# *Inspection Photos*

*API# 071-06409*

*Operator: Timber Creek*

*Inspection Number: 680102744*

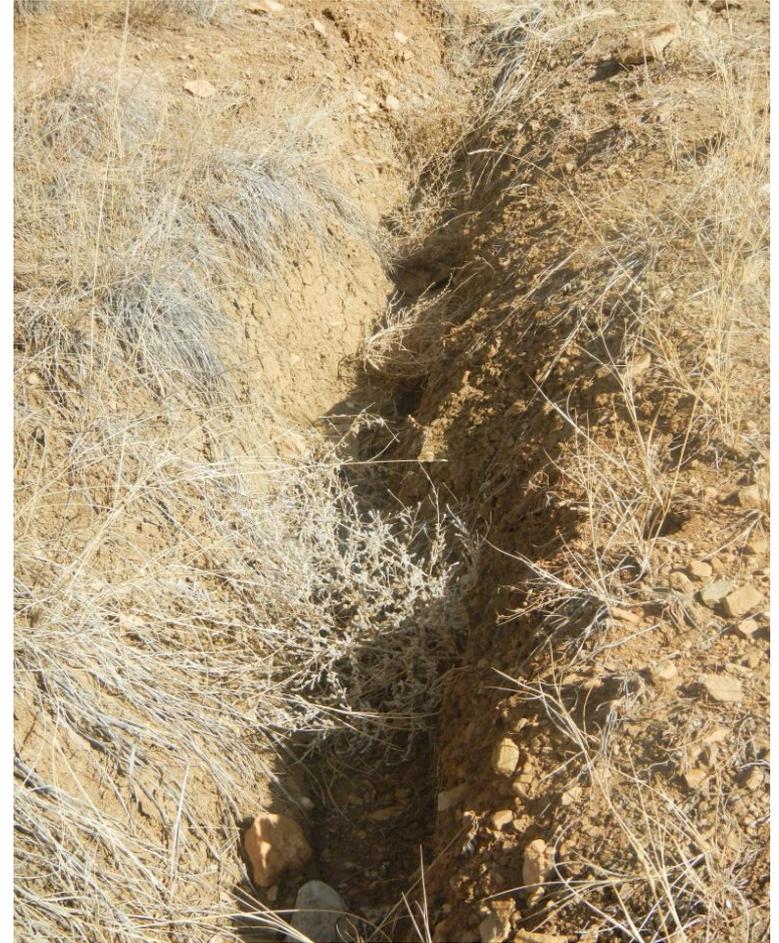
**Photo#3:**  
Ditch that conveys stormwater from lease road through failed vegetation area of location is eroding & needs to be stabilized.

**Photo#4:**  
Refer to Photo#3 description
